Product / Process Change Notification (PCN)

PCN #: PCN_IndHCF_20200302 Affected Series: WE-HCF-2920; 74437429203xxx; 74437529203xxx PCN Date: December 02, 2019 Effective Date: March 02, 2020	Change Category: <input type="checkbox"/> Equipment / Location <input type="checkbox"/> General Data <input type="checkbox"/> Material <input type="checkbox"/> Process <input type="checkbox"/> Product Design <input checked="" type="checkbox"/> Shipping / Packaging <input type="checkbox"/> Supplier <input type="checkbox"/> Software
Contact: Product Management Phone: +49 (0) 7942 - 945 5001 Fax: +49 (0) 7942 - 945 5179 E-Mail: pcn.eisos@we-online.com	Data Sheet Change: <input checked="" type="checkbox"/> Yes <input type="checkbox"/> No Attachment: <input type="checkbox"/> Yes <input checked="" type="checkbox"/> No

BEFORE CHANGE

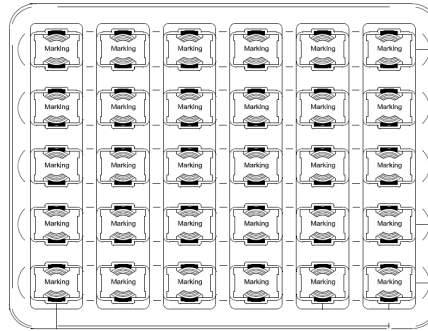
To improve the handling and transportation safety, Würth Elektronik will change the packaging method of HCF 2920 series.

Unit	New Packaging	Old Packaging
Carton Packaging Quantity (CPQ)	pcs	160	270
Standard Packaging Quantity (SPQ)	pcs	20	30
Number of plastic trays	pcs	8	9
Plastic tray dimensions	mm	245 x 195 x 23	245 x 195 x 22
Number of inner carton boxes	pcs	8	1
Inner carton dimension	mm	265 x 205 x 30	260 x 210 x 235
Outer carton box dimensions	mm	275 x 232 x 255	275 x 232 x 255
Foam protection		No	Yes
